**Re: Comments on the Initial Study / Mitigated Negative
Declaration for Use Permit #2020-004, Initial Study #2020-001,
SCH # 2020100366, Dr. Charles Hooper**

The Project proposes to construct a 50-megawatt ("MW") photovoltaic solar array and a battery energy storage system ("BESS") that would store 25 MW or 100 MW hours of electricity, along with related infrastructure.¹ Such infrastructure would include a substation, a dead-end tower up to 90 feet tall, 24 130-foot tall steel gen-tie line poles to interconnect with the Plumas-Sierra Rural Electric 120 kilovolt

Figure 1. Proposed Project site and gen-tie (red lines) in relation to lands owned in fee and protected for open space purposes by the BLM, CDFW, and CA State Lands Commission.

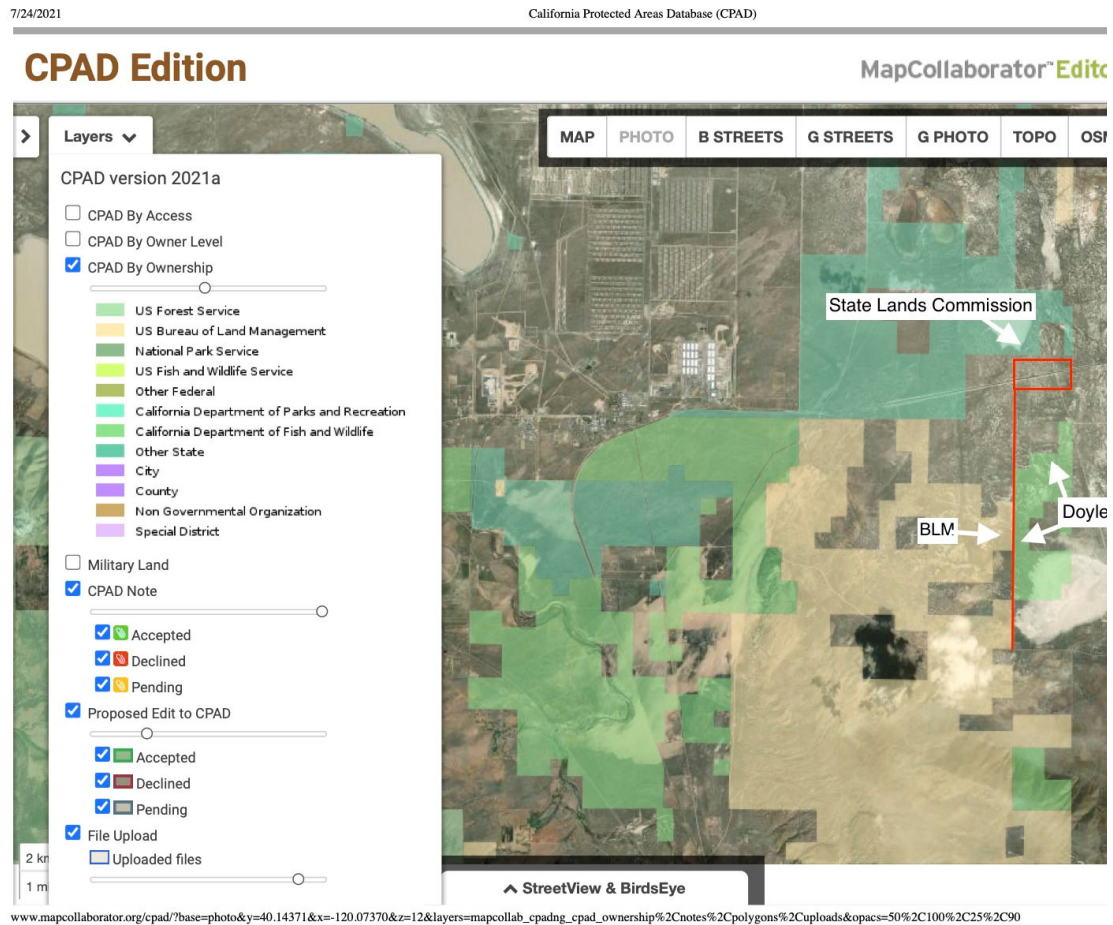
Land Management (“BLM”) and California Department of Fish and Wildlife (“CDFW”) (See Figure 1 below).⁷⁶ The proposed Project includes permanent removal of “deep-rooted vegetation” within a 30-foot-wide strip centered on electrical infrastructure facilities.⁷⁷ Accordingly, if the electrical infrastructure facilities associated with the Gen-Tie are located at the edge of Calneva Road, permanent impacts to vegetation would extend at least 15 feet into protected lands owned by the BLM or CDFW (depending on whether the gen-tie is installed on the east or west side of Calneva Road).⁷⁸

By omitting these lands from the MND’s description of environmental setting, the MND omits critical details regarding the Project’s impacts. These impacts must be disclosed and analyzed in an EIR.

Figure 1: PM and NO_x Emissions by Tier for a Backhoe²⁵

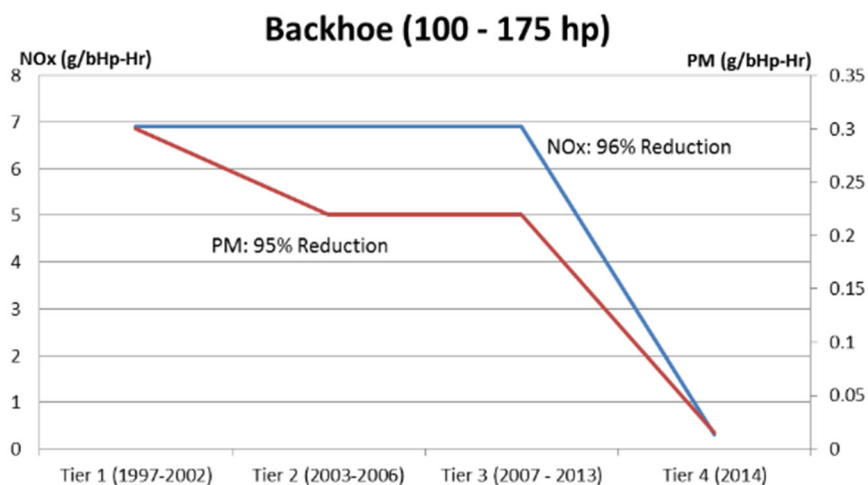
Figure 1 shows that NOx exhaust emissions would be about 35 (7/0.2) times higher if all Tier 1 construction equipment were used instead of Tier 4 equipment. Similarly, this figure shows that PM exhaust emissions would be about 15 (0.3/0.02) times higher if all Tier 1 equipment were used instead of Tier 4 equipment. Thus, if the Project's CalEEMod analysis assumed Tier 1 equipment, NOx emissions would increase from 19.1 lb/day to 668 lb/day,²⁶ which exceeds the significance threshold of 150 lb/day. Particulate matter emissions would increase from 109.59 lb/day to 1,645.8 lb/day,²⁷ which exceeds the significance threshold of 150 lb/day.

Figure 2: Location of the Beckwourth Fire¹⁷²

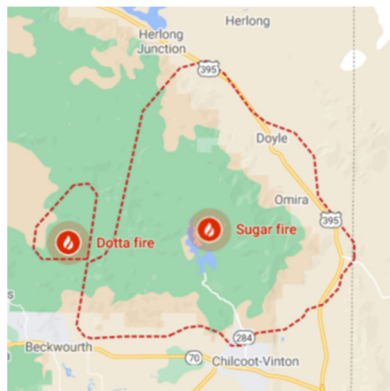
Further, a catastrophic wildfire is currently burning south of the Project. The Beckwourth Complex Fire, Figure 2, the largest wildfire of the year so far in California,¹⁶⁴ is currently burning near the Project location, roughly 42 miles south of Herlong.¹⁶⁵ This fire is a combination of two lightning-caused fires near the community of Beckwourth.¹⁶⁶ The fire covers 100,531 acres and is currently only 68%

However, the IS/MND is silent on vegetation in the surrounding areas, most notably along the Gen-Tie and outside of the Project site that could serve as fuel for the start of a similar fire, which could spread onto the Project site. Further, the IS/MND fails to evaluate potential fire impacts, which could be triggered by lightening, other external factors, or accidents at the BESS facility. See Comments 5 to 6.5.7.

Figure 2. Proposed Project site (yellow rectangle) in relation to the geographic range of the Carson wandering skipper (shaded blue).⁵²

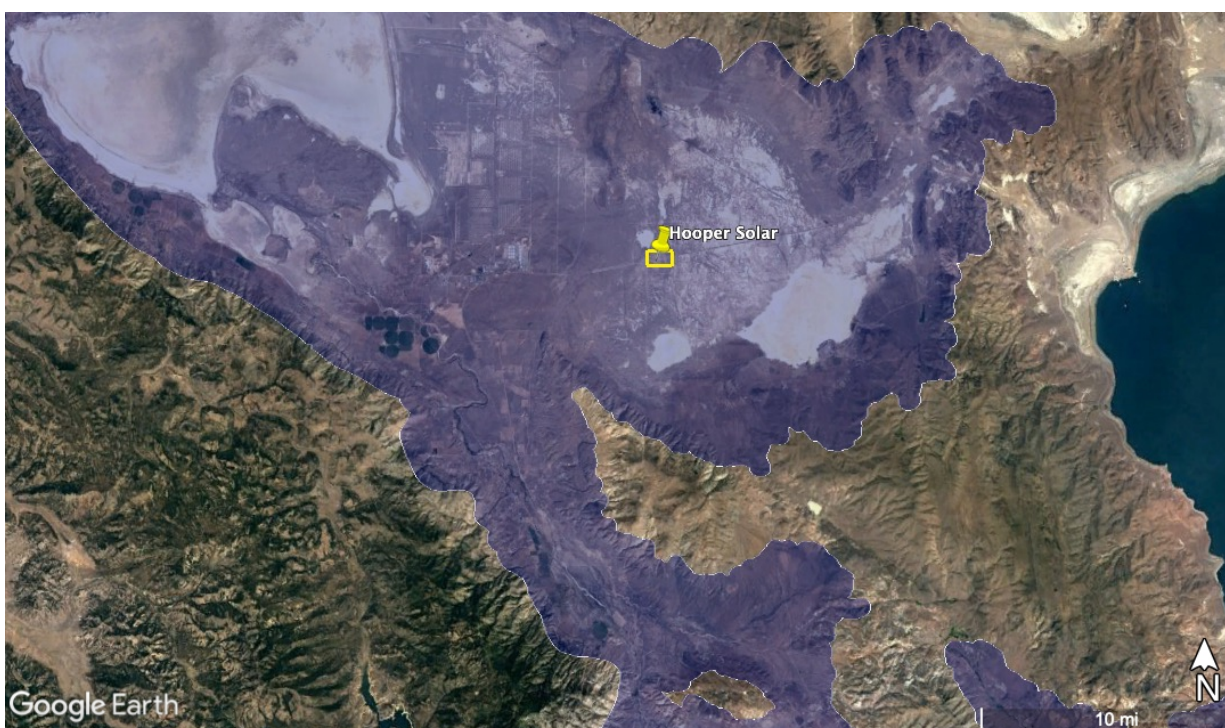
believed to be four extant populations of the Carson wandering skipper: three in Nevada and one in Honey Lake Valley, California.⁴⁸ The Project site and gen-tie line ROW are within the range of the Carson wandering skipper (Figure 2).⁴⁹
